Planning Application for rear garden deck, balustrade and screen at 28 Lyndhurst Road, London NW3 5PB

Proposed Deck & Screening to Rear Garden of 28 Lyndhurst Road, London NW3 5PB

Appendix 6
Email dated 12th
August 2016
from LBC

SECTION Y-Y THROUGH EXISTING TERRACE

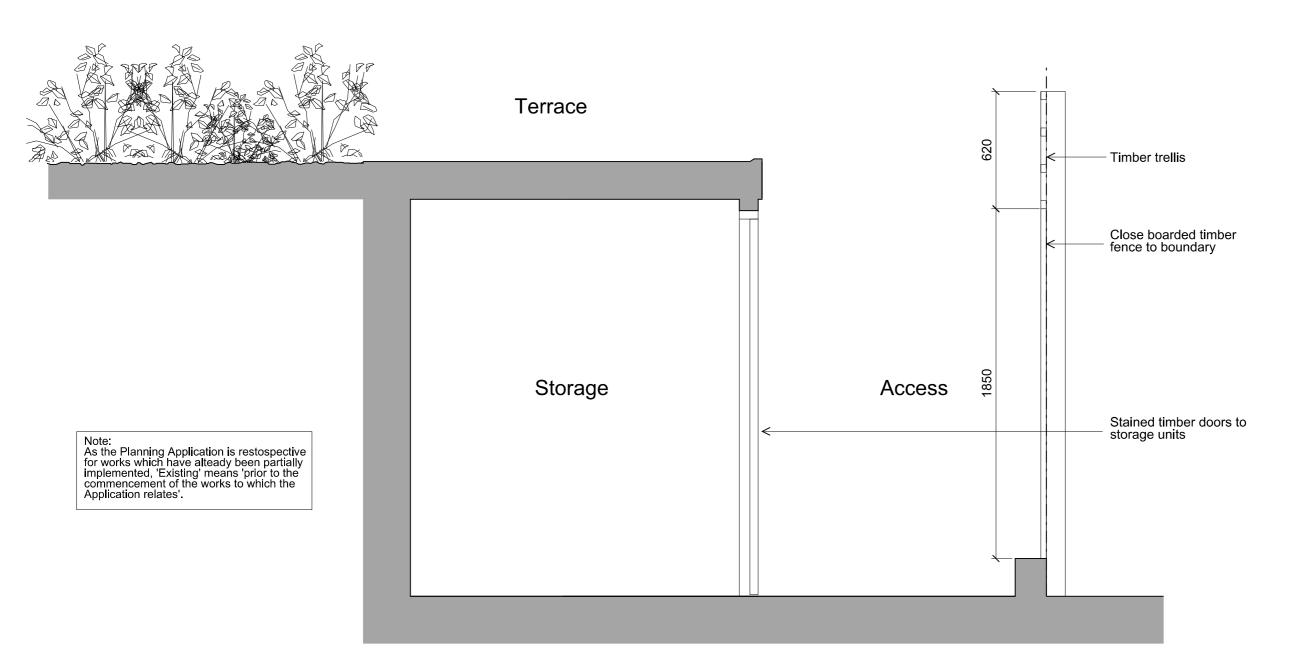
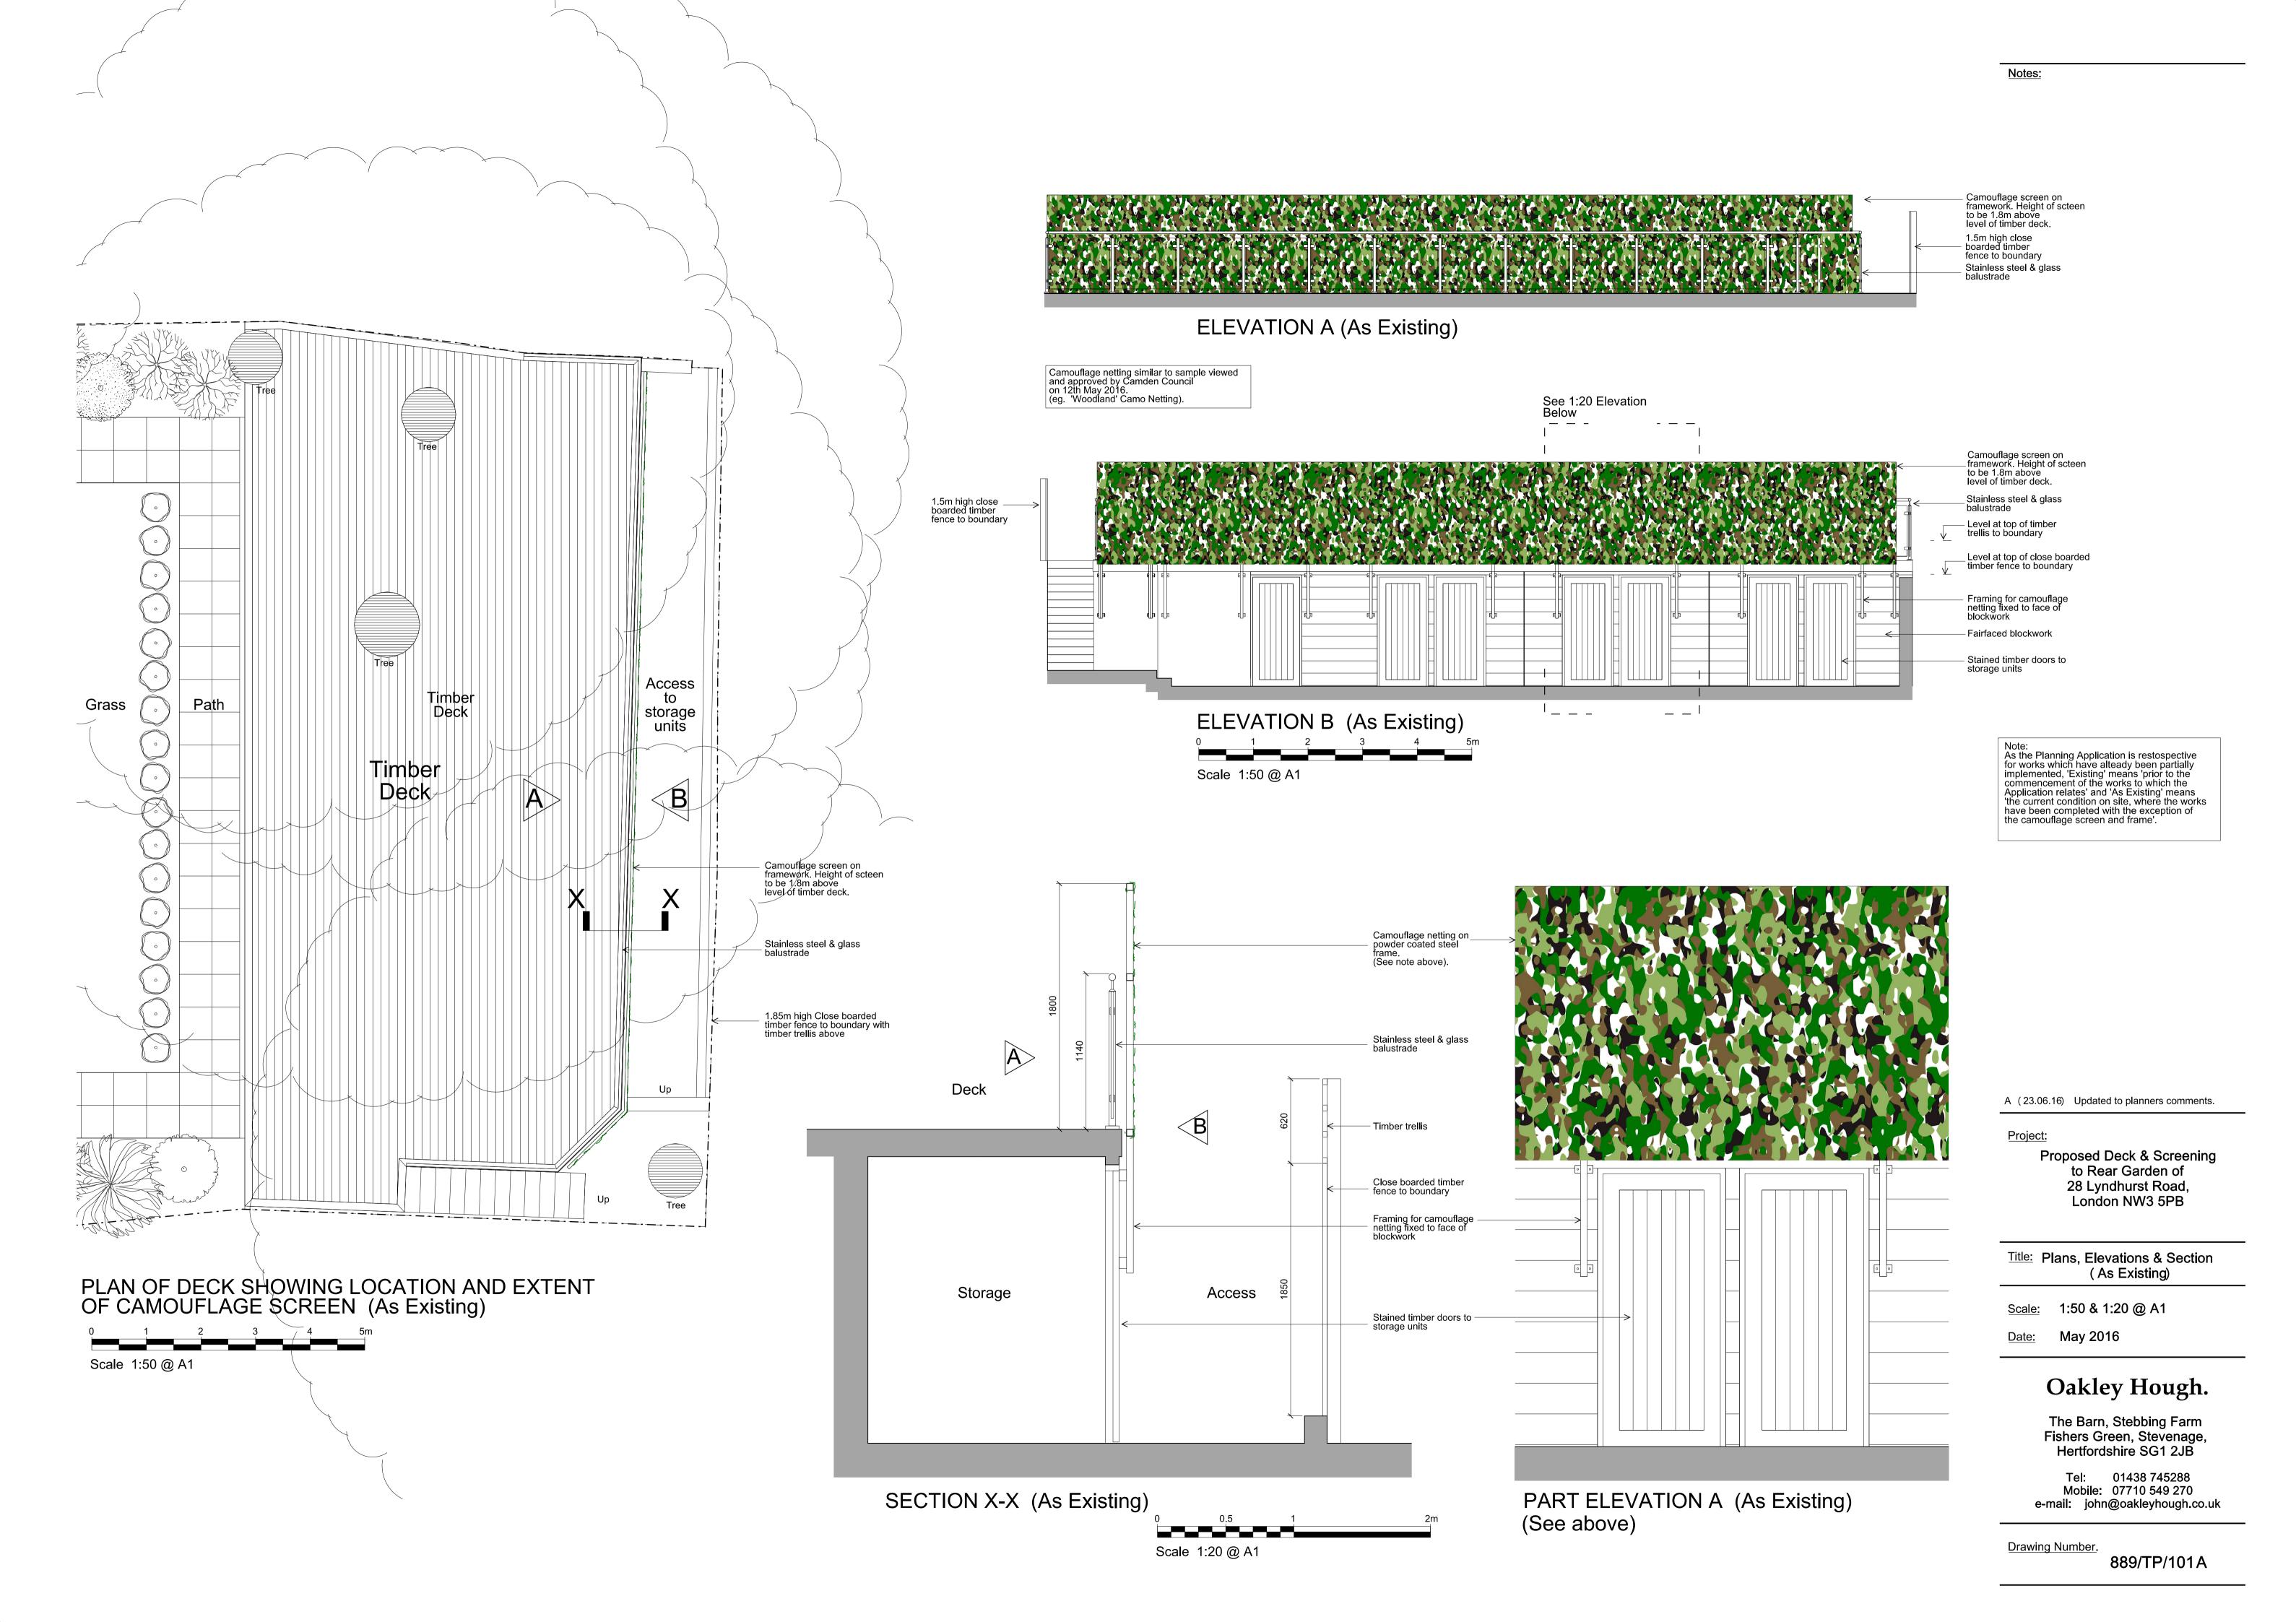
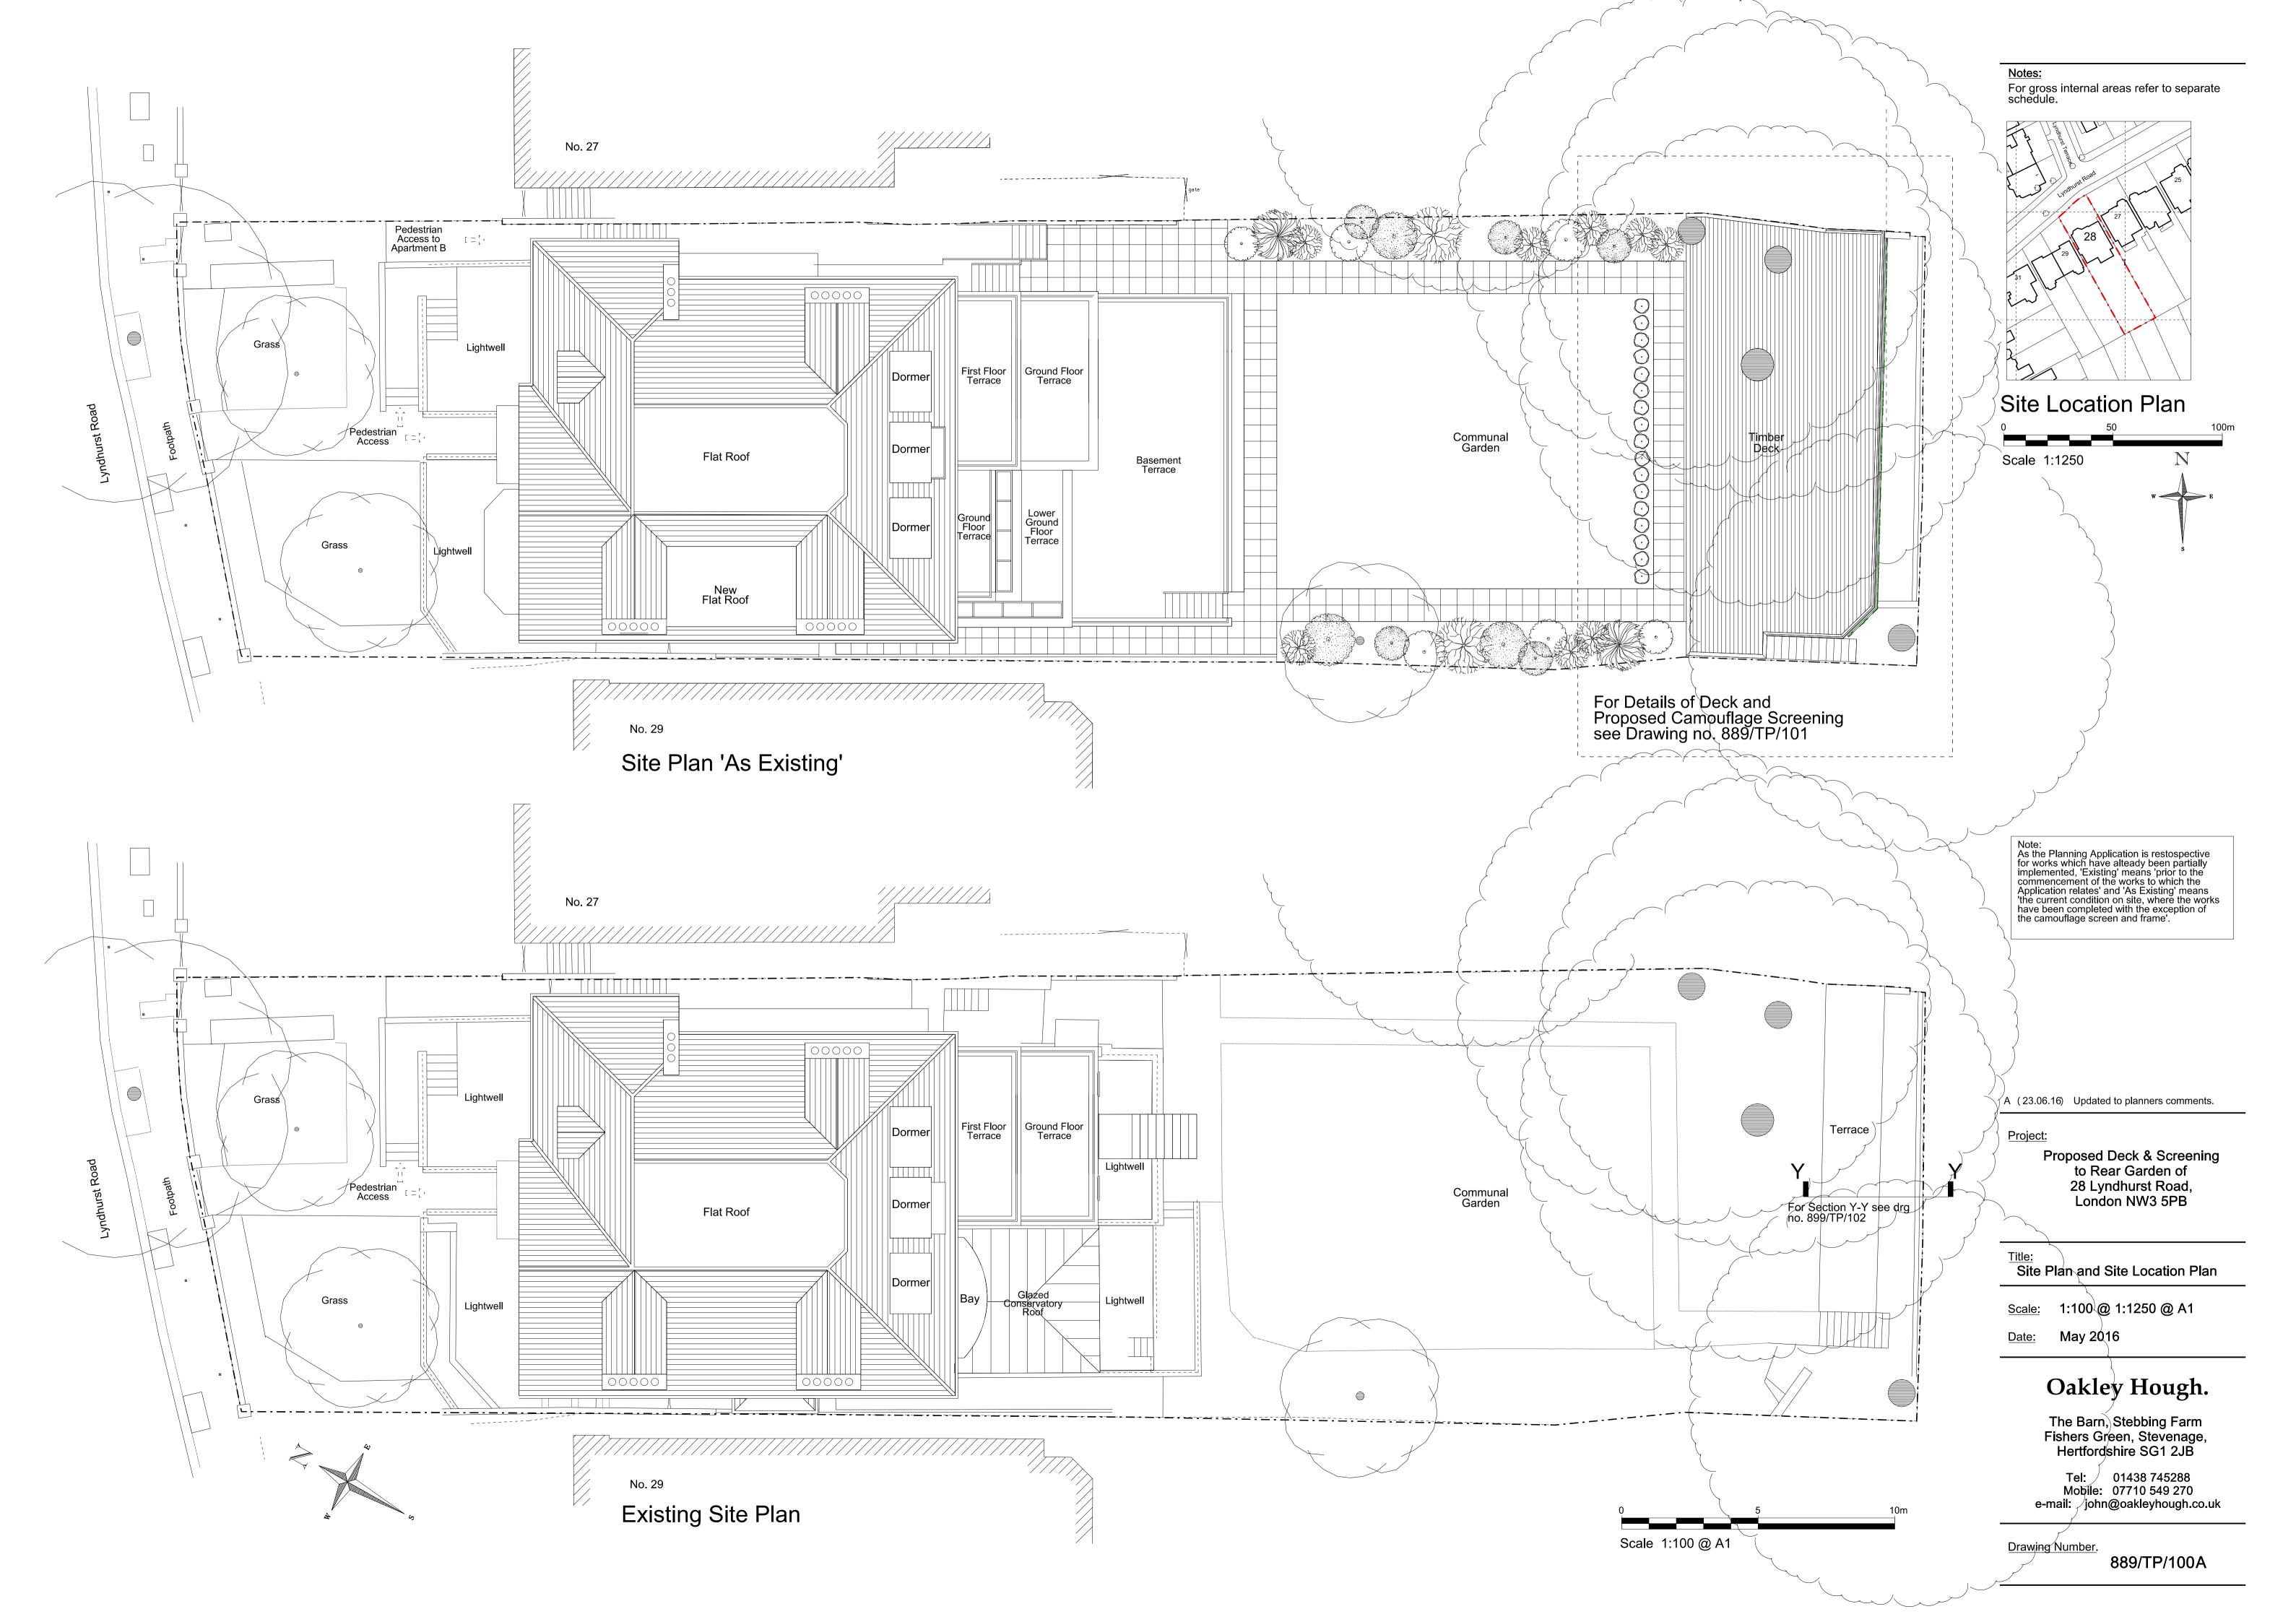
Further to my site visit on Friday, I wish to advise we would not approve the roof terrace as it stands.

The size and scale of the terrace is completely inappropriate to the surroundings and would be detrimental to the character of the conservation area.

- Furthermore, the plans submitted are not accurately representative of the site due to the raise in levels of approximately 16cm.
- 4. An Arboricultural Report was not submitted to sufficiently demonstrate protection to the trees. We require this to be submitted as I have discussed with our landscaping officer and we are not convinced the trees have been suitably protected.

As such, I request that amendments are made to the plans to address the above information. We would accept a roof terrace that is set back further from the rear boundary line so that no screening is required to prevent overlooking and of a sufficiently smaller scale (at least half of the width of the existing). We would then be able to grant approval subject to enforcement action which would require you to amend the roof terrace to comply with the approved plans.

Further to our recent telephone conversation on the subject of your email to Simon (see below) I have discussed your comments with my Client and have attached a drawing of a revised scheme for your consideration.

Here we have done as you requested by reducing the size of the terrace by 50%, setting the terrace back 5000mm from the rear boundary and delineating the back of the terrace by a row of planters. The concrete roof of the existing storage units will now be covered with artificial grass, as real grass would not flourish under the trees. We have had to retain the balustrade for safety reason, as required under the Building Regulations.
